Bulletin No.: L16-001
Release Date: 3/16/16
Effective Date: Immediately
Supercedes: N/A
Completion Date: N/A

SERVICE BULLETIN

Ride Manufacturer: Larson International Inc. **Affected Production Dates: All**
Ride Name: FLYING SCOOTERS **Affected Serial Nos.: 14-26, 30**

Abstract Of Issue: **Install a set of normally closed contacts in the E-stop button.**

TITLE:
FLYING SCOOTERS ELECTRICAL (480V)
DRWG./PART NO:
LC340138 (480V – W/ LEDS)

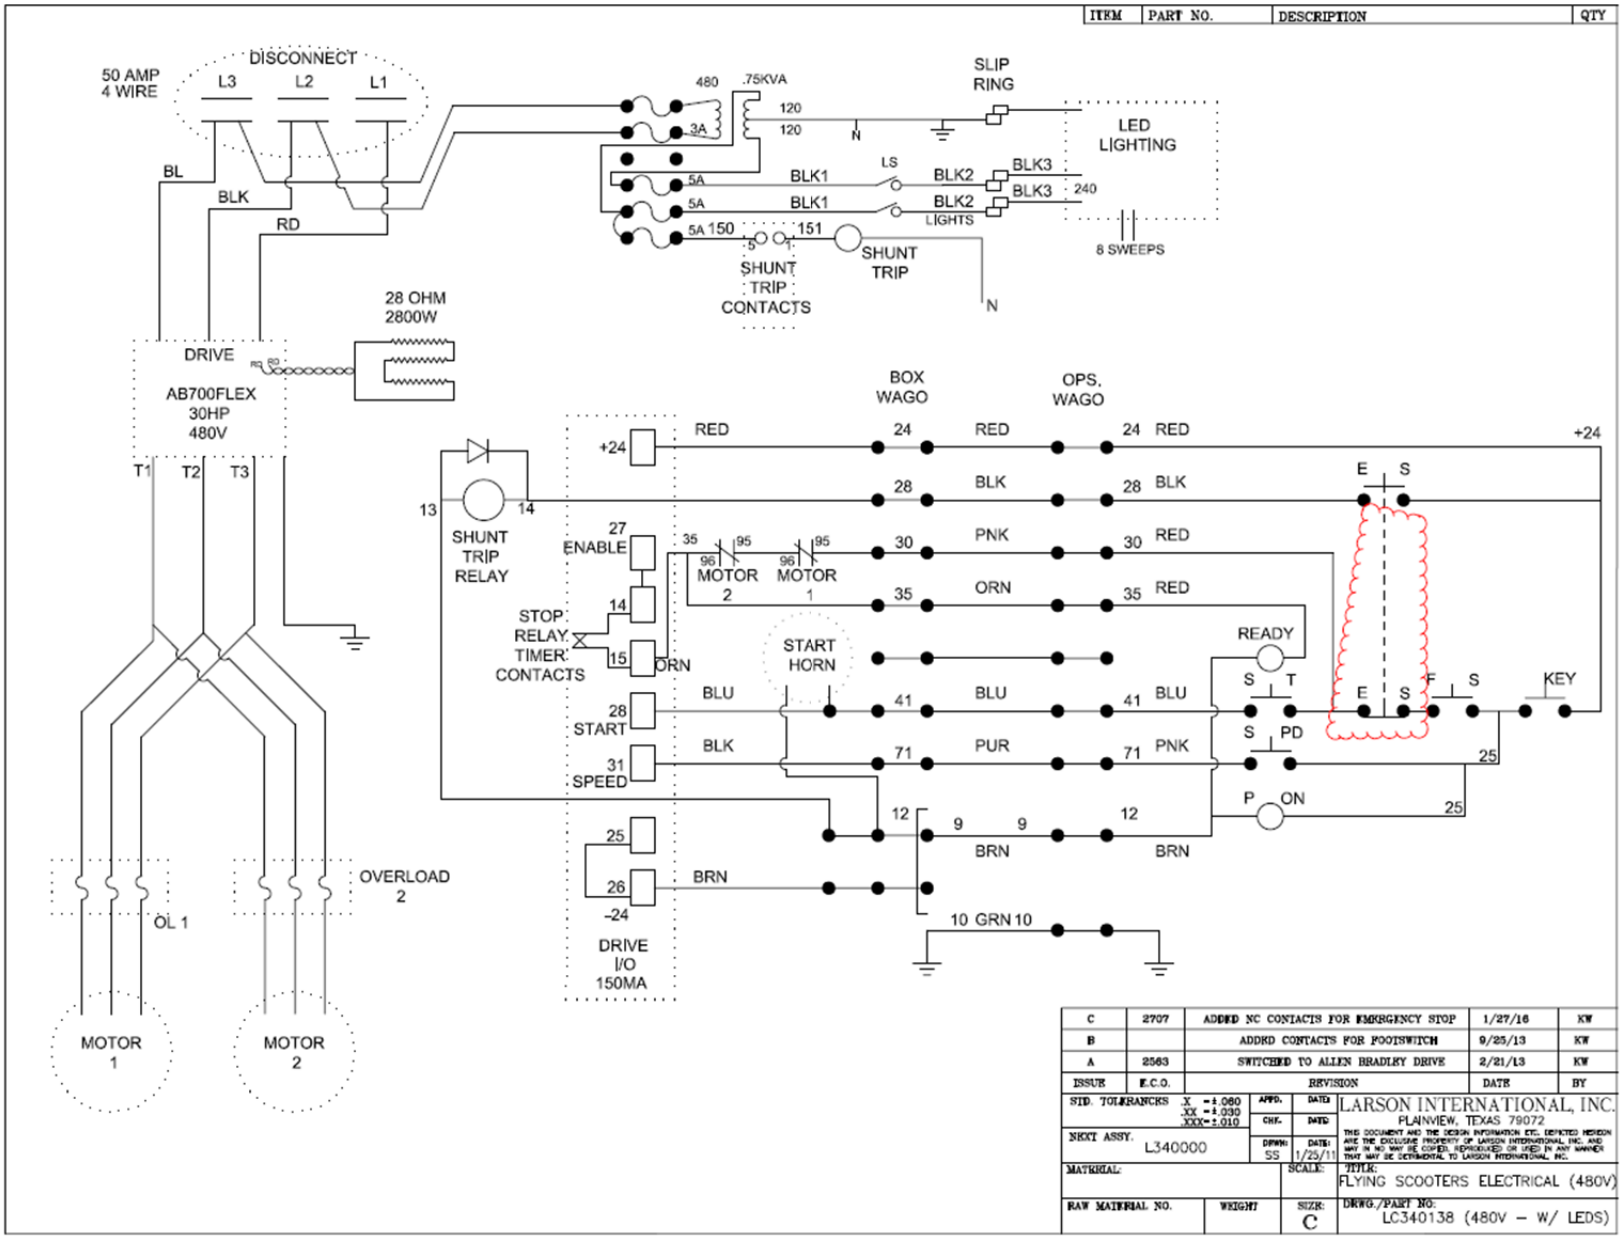
Reason for Release: **A failure of the 120V power supply circuit can cause the E-stop to not stop the ride when pressed.**

Action To Be Taken: **Install a set of normally closed contacts in the E-stop wired as shown on page 2.**

Revised Electrical Schematic on page 2.
